EARLSDON LIVEABLE NEIGHBOURHOOD SCHEME
STAGE 3 ROAD SAFETY AUDIT

- 1.1** This report describes a Stage 3 Road Safety Audit carried out in Earlsdon, Coventry. The scheme drawings were designed and submitted by Coventry City Council, Transport & Infrastructure Team.

Location: Beechwood Avenue, southeast of Stoneleigh Avenue

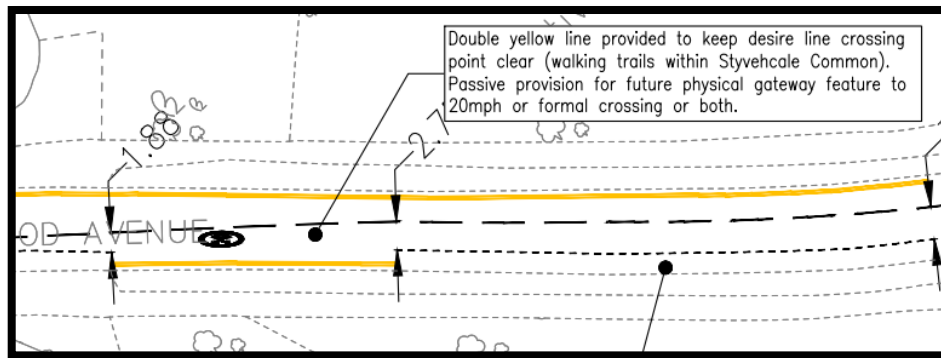
Parking bays are proposed opposite each other. This reduces the width of the available carriageway when both parking bays are occupied to one car width and increases the risk of conflicts between vehicles, and between vehicles and cyclists.

The Audit Team are not satisfied that this item has been resolved and therefore this road safety problem remains outstanding.

Parking bays should be staggered to facilitate two-way traffic to reduce the potential of personal injury collisions related to the reduced carriageway width.

Location: Beechwood Avenue, southeast of Woodlands Avenue

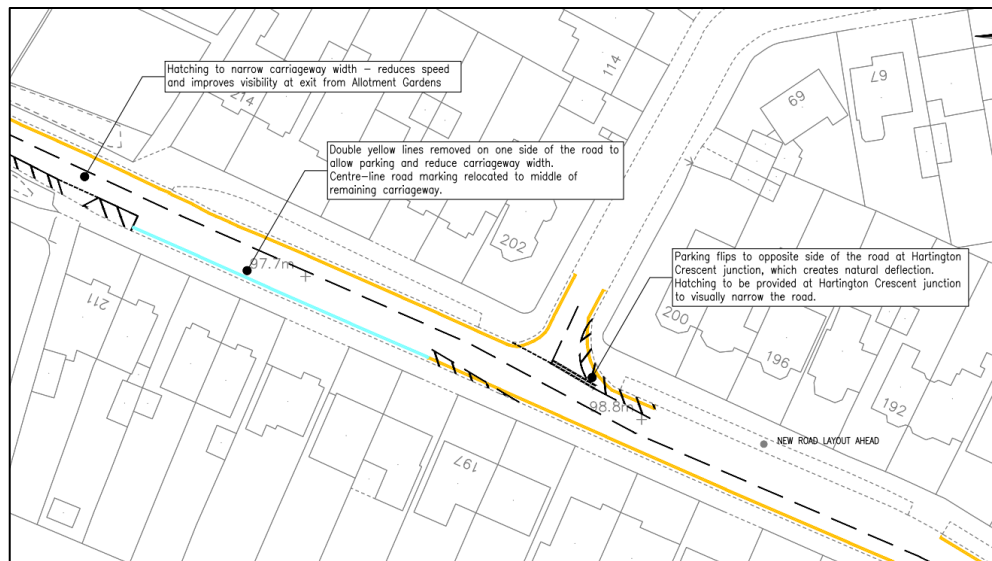
No pedestrian and cycle crossing facilities are proposed on the identified desire line between trails within Styvechale Common. This increases the risk of vehicle colliding with vulnerable road users (particularly those with visual and/or mobility impairments, those with pushchairs, and cyclists) as they cross.

The Audit Team are not satisfied that this item has been resolved and therefore this road safety problem remains outstanding.

Pedestrian crossing facilities should be provided on the desire line. This will reduce personal injury collisions related to vulnerable road users crossing at informal crossing points.

Warwick Avenue, junction with Beechwood Avenue

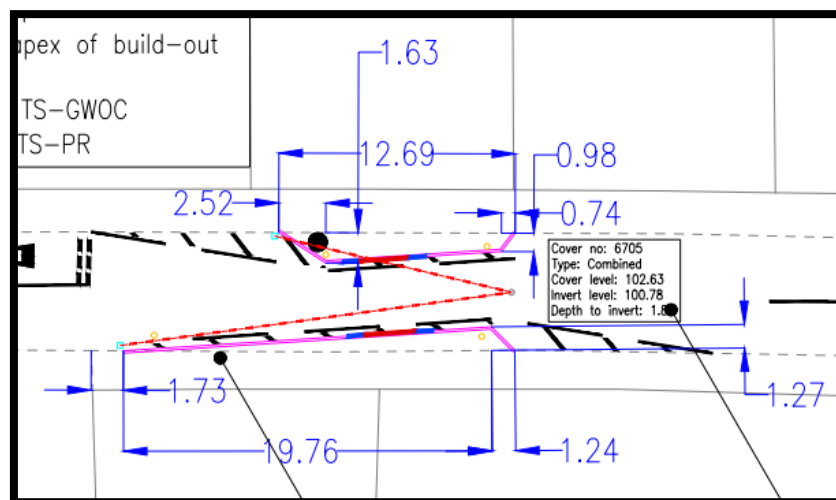
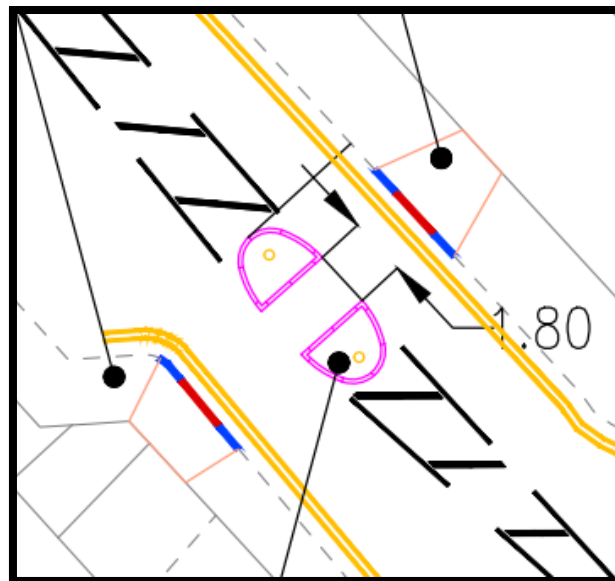
The submitted drawings for the above junctions do not show pedestrian crossing points and tactile paving. A lack of designated pedestrian crossing points may result in visually-impaired pedestrians crossing at an unsafe location. This increases the risk of vehicle to pedestrian type collisions.

The Audit Team are not satisfied that this item has been resolved and therefore this road safety problem remains outstanding.

Designated pedestrian crossing points with tactile paving should be provided at all junctions. The crossing points should be in locations that maximise inter-visibility between pedestrians and drivers and take into account the presence of trees in the footway (see example below).

Location: Beechwood Avenue, north of Styvechale Avenue

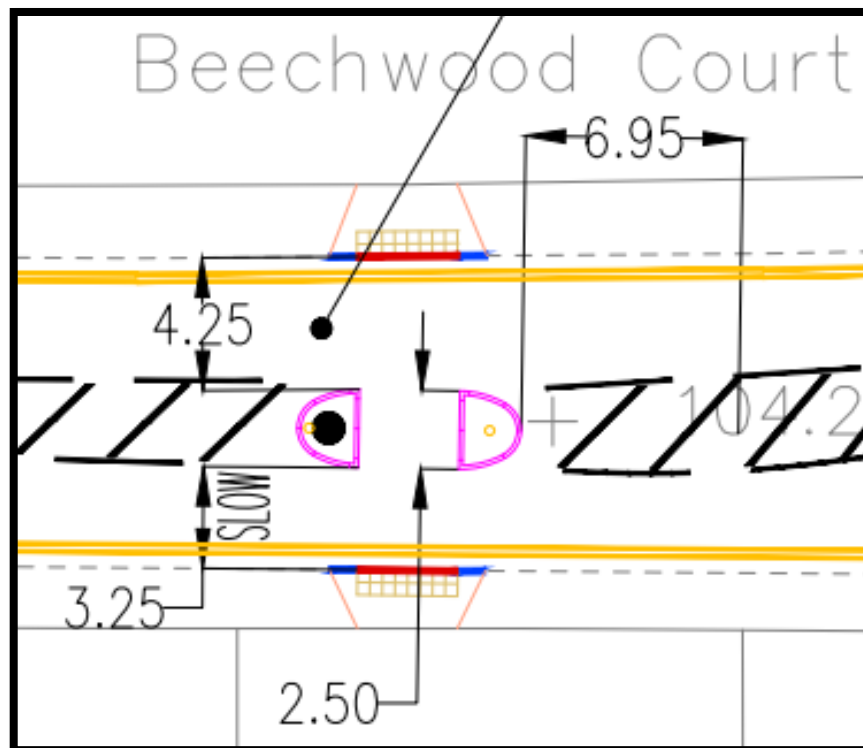
The submitted plans do not specify the width of the carriageway at the proposed pedestrian refuge and priority chicane. Carriageway widths of between 3.1m and 3.9m at pinch points can result in close overtaking of cyclists by drivers. This increases the risk of vehicle to cyclist type collisions.

The Audit Team are not satisfied that this item has been resolved and therefore this road safety problem remains outstanding.

The carriageway width either side of the refuge and at the chicane should be a minimum of 3.9m, or cycle bypasses should be provided.

Location: Beechwood Avenue, south of Rochester Road

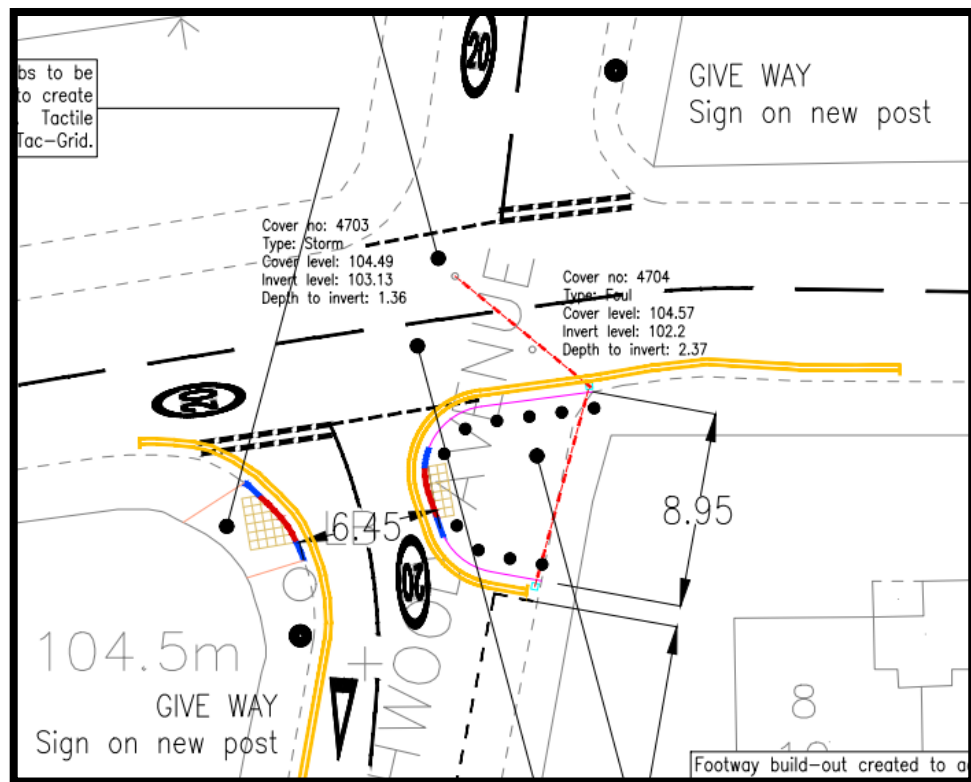
The proposed width of the westbound traffic lane at the proposed pedestrian refuge is 3.25m. Carriageway widths of between 3.1m and 3.9m at pinch points can result in close overtaking of cyclists by drivers. This increases the risk of vehicle to cyclist type collisions.

The Audit Team are not satisfied that this item has been resolved and therefore this road safety problem remains outstanding.

The carriageway width either side of the refuge should be a minimum of 3.9m.

Location: Beechwood Avenue, junction with Rochester Road

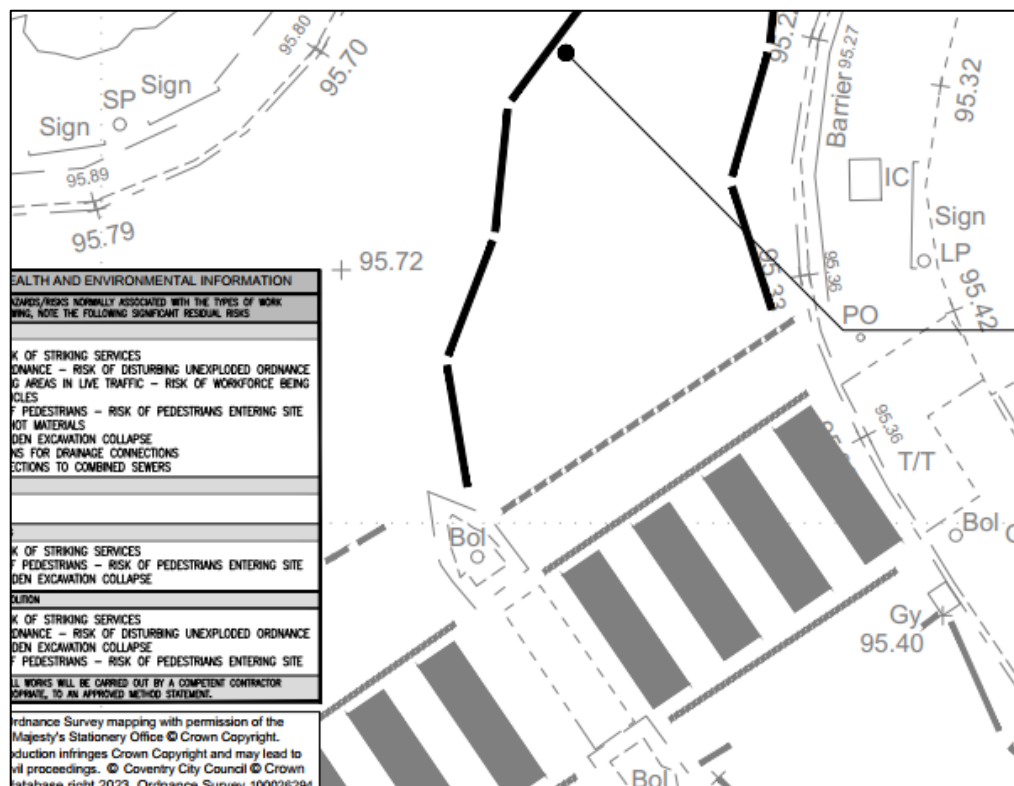
The submitted plans do not include vehicle tracking to demonstrate that large vehicles can undertake all movements at the junction safely. Large vehicles may have to enter the path of oncoming traffic or overhang the footway in order to manoeuvre through the junction. This increases the risk of vehicle to vehicle and vehicle to pedestrian type collisions.

The Audit Team are not satisfied that this item has been resolved and therefore this road safety problem remains outstanding?

An assessment of vehicle swept paths should be undertaken and any necessary changes made to the proposed highway layout to ensure that large vehicles can undertake all movements at the junction safely.

Location: Earlsdon Avenue South

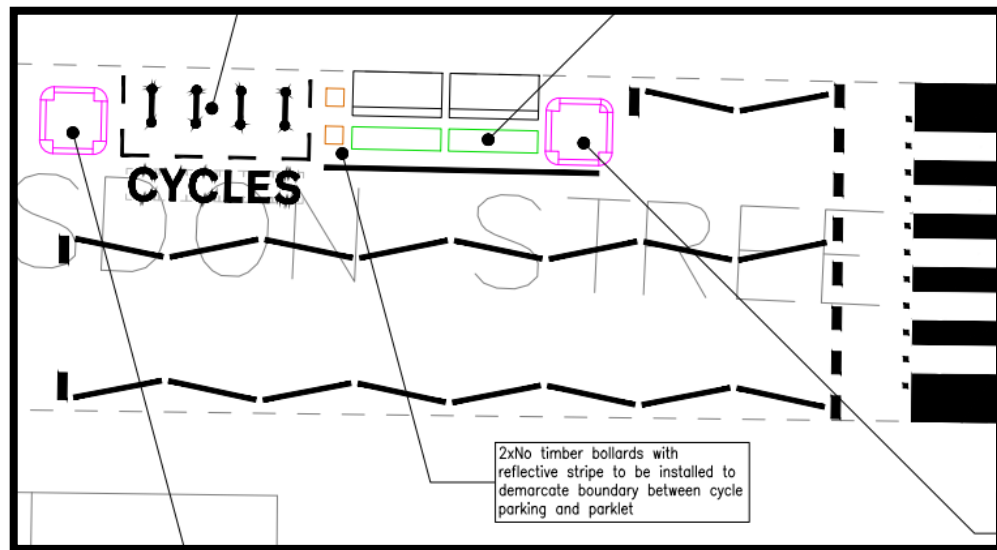
The zebra crossing is located immediately adjacent to the roundabout. This increases the risk that drivers concentrating on negotiating the roundabout not seeing a pedestrian crossing. Furthermore, vehicles exiting the roundabout have to wait in the circulatory area to allow pedestrians to cross and a vehicle waiting at the give way line of the roundabout obstructs the zebra crossing. These issues increase the risk of rear shunts and vehicle to pedestrian type collisions.

The Audit Team are not satisfied that this item has been resolved and therefore this road safety problem remains outstanding.

The zebra crossing should be relocated away from the roundabout to enable vehicles to wait without obstructing the circulatory area or the zebra crossing.

Location: Earlsdon Street, on approach to zebra crossing

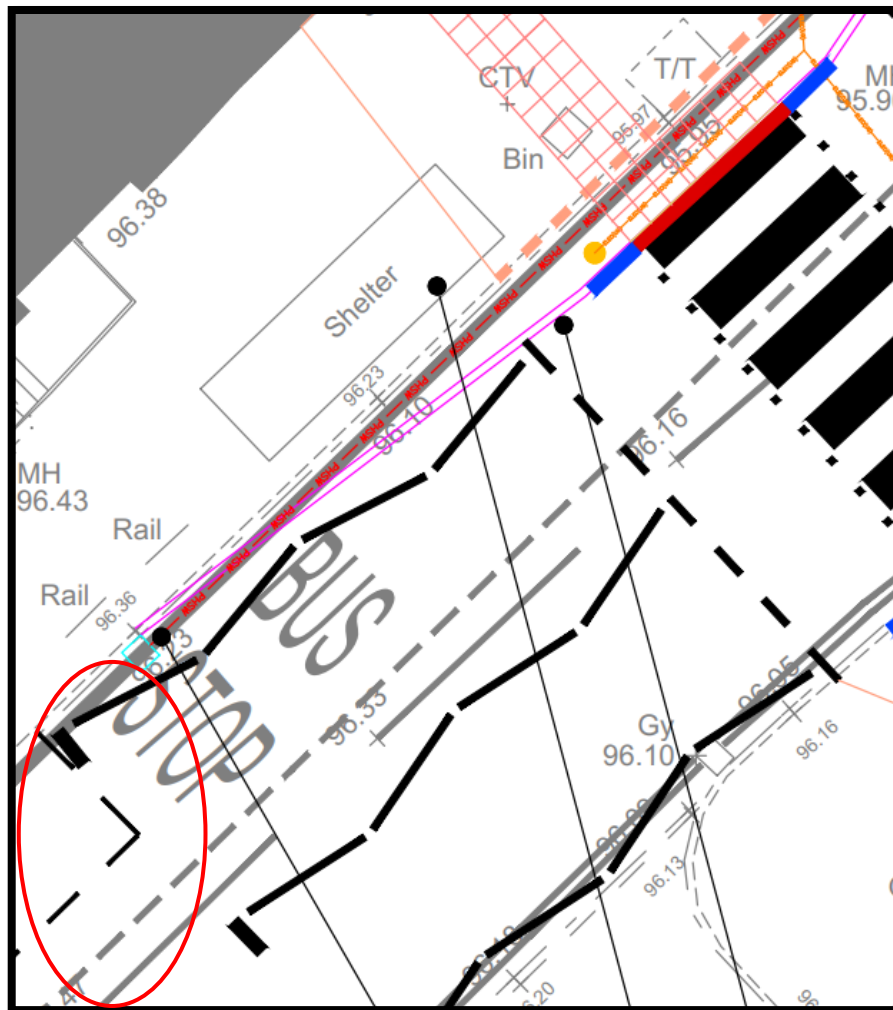
Street furniture including cycle parking and seating is proposed in the pedestrian visibility splay and current controlled area of the zebra crossing. This may obstruct drivers' visibility of pedestrians waiting at the crossing and reduces the width of the north eastbound traffic lane to less than the minimum width required. This increases the risk of vehicle to vehicle and vehicle to pedestrian type collisions.

The Audit Team are not satisfied that this item has been resolved and therefore this road safety problem remains outstanding.

The proposed street furniture should be relocated outside the extents of the current controlled area.
